Access Compliance Report

Public Rights-of-Way

(Pedestrian Signals)

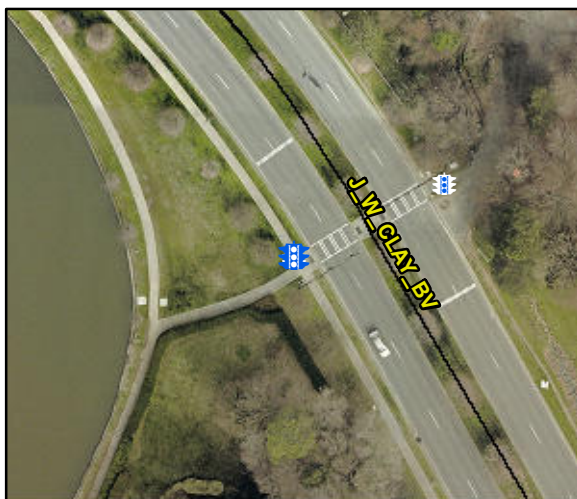
PROW/ADA: R404.2, R404.7.2, R209.1,
MUTCD 4e.10

N/A	B 1 FWD Approach Width (in)	N/A	N/A	B 2 FWD Approach Width (in)	N/A
N/A	B 1 FWD Approach Obstruction?	Yes	N/A	B 2 FWD Approach Obstruction?	N/A
N/A	B 1 FWD Approach Obstruction Dist (in)	4.0	N/A	B 2 FWD Approach ObstructionDist (in)	N/A
N/A	B 1 PARA Approach?	Yes	N/A	B 2 PARA Approach?	N/A
N/A	B 1 PARA Approach Constrained?	Yes	N/A	B 2 PARA Approach Constrained?	N/A
Yes	B 1 PARA Approach Reach (in)	6.0	N/A	B 2 PARA Approach Reach (in)	N/A
No	B 1 PARA Approach Width (in)	48.0	N/A	B 2 PARA Approach Width (in)	N/A
N/A	B 1 PARA Approach Obstruction?	Yes	N/A	B 2 PARA Approach Obstruction?	N/A
N/A	B 1 PARA Approach Obstruction Dist (in)	4.0	N/A	B 2 PARA Approach ObstructionDist (in)	N/A
Yes	B 1 Clear Floor Space Slope (%)	1.3	N/A	B 2 Clear Floor Space Slope (%)	N/A
No	B 1 Clear Floor Space XSlope (%)	3.6	N/A	B 2 Clear Floor Space XSlope (%)	N/A
N/A	B 1 PAR Slope (%)	N/A	N/A	B 2 PAR Slope (%)	N/A
Yes	B 1 Height (in)	38.0	N/A	B 2 Height (in)	N/A

Possible Solutions: Remove & Replace
Replace APS Button With New APS Button.
Remove and Replace Clear Space.
